EXAMINER
MCKANE, ELIZABETH L

Office Action Summary

10/756,214

DOSHI, RAJIV

FIG. 4

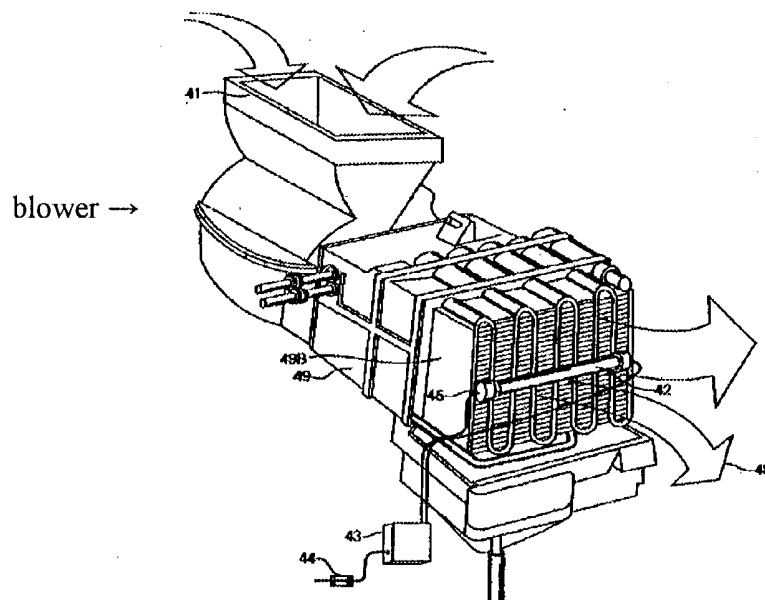
2. Claims 1-3, 8-10, 13, 17-19, 24-26, and 29 are rejected under 35 U.S.C. 102(b) as being anticipated by Hollander (U.S. Patent No. 5,334,347).

Hollander teaches an HVAC system and method for a motor vehicle comprising a UV bulb **42** for treating microorganisms with the HVAC system. The UV bulb emits light at 254 nm (UVC). See Figure 3. The UV bulb **42** is located in the post-blower (unlabeled) portion of the HVAC system, adjacent and downstream of the evaporator **49B** at the air exit **48**.

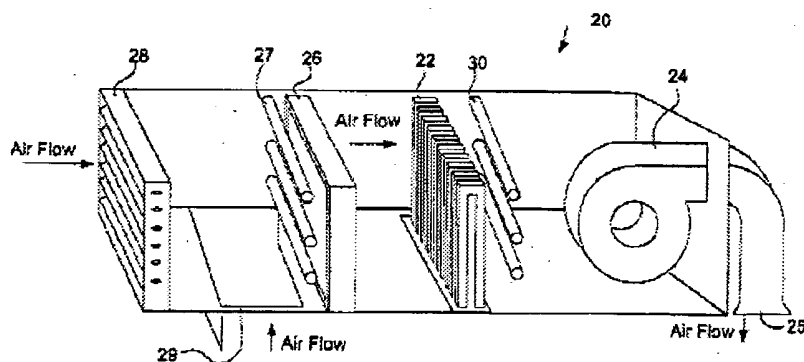
5. Claim 16 is rejected under 35 U.S.C. 103(a) as being unpatentable over Hollander.

Although Hollander does not expressly teach that the HVAC system has a plurality of conduits for communicating air within the vehicle, it is well-known in the art that the HVAC systems of motor vehicles have a plurality of conduits, evidenced by the multiple air vents within a vehicle interior. Moreover, Hollander discloses that the interior of the air duct “is reflective of the ultraviolet energy (254 nm)” in order to direct the UV radiation throughout the duct and to intensify sterilization effects. See col.7, lines 34-39. For this reason, it would have been obvious to fabricate the interior of all air ducts of a reflective material.
